ADDENDUM #1

TO CONTRACT DOCUMENTS ENTITLED: Project #CP241341 Various Locations – FY24 Summer Paving Project – Asphalt

CONSULTANT: MECO Engineering Co., Inc.
2701 Industrial Drive, Jefferson City, MO 65109
573-893-5558
Project Number 473-070

ALTERNATE BID NO. 1
SG4/M STRIPING PLAN

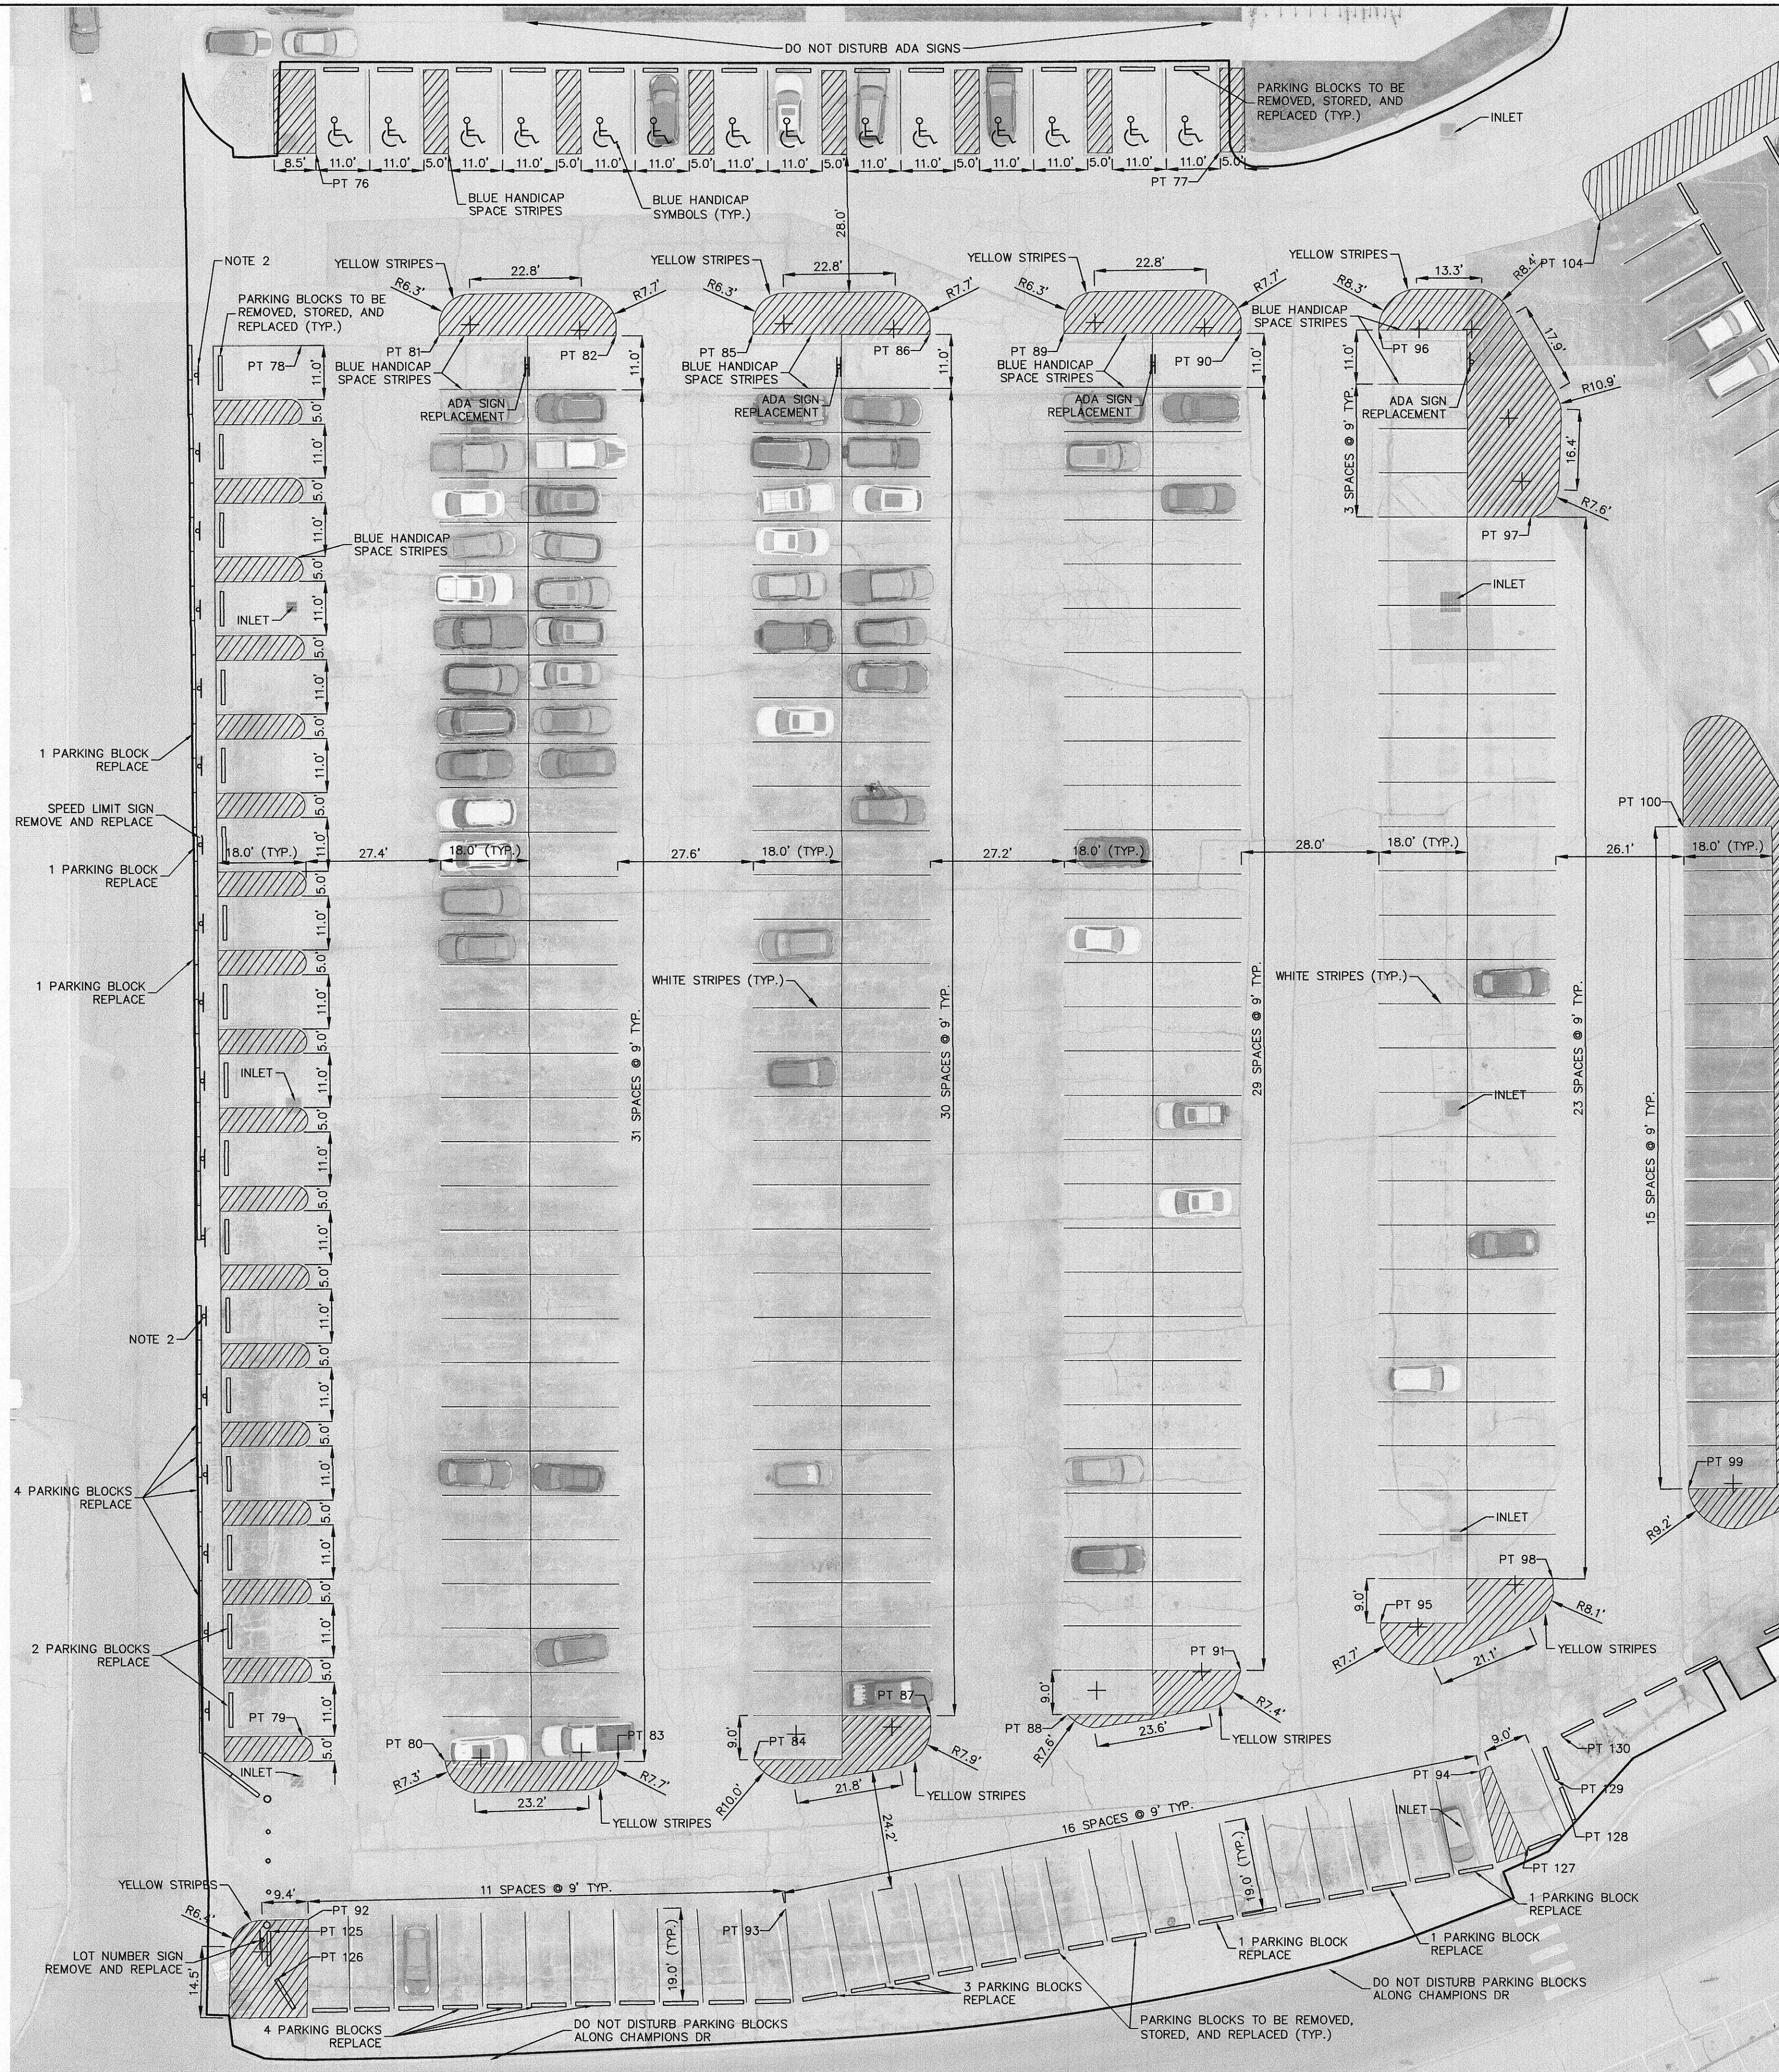
- 4) Add Section 1.F Index of Drawings: The index of sheets has additional sheets representing the Alternate Bid: Sheet No. 15: Alternate Bid No. 1, SG4/M Sign Location and Traffic Control; Sheet No. 16 and 17: Alternate Bid No. 1, SG4/M Repair Plan; and Sheet No. 18 and 19: Alternate Bid No. 1, SG4/M Striping Plan

- 1) Sheet No. 1 Cover Sheet: Change the Drawing Index to include:
Sheet 15: Alternate Bid No. 1, SG4/M Sign Location and Traffic Control
Sheet 16 and 17: Alternate Bid No. 1, SG4/M Repair Plan
Sheet 18-19: Alternate Bid No. 1, SG4/M Striping Plan
- 2) Add Sheets 15-19, marked Alternate Bid No. 1, to the Plan Set.
- 3) Sheet No. 3 Sign Location and Traffic Control, Detail SG7/A and SG7/B remove the two movable barricades indicated on the drive to the tunnel.
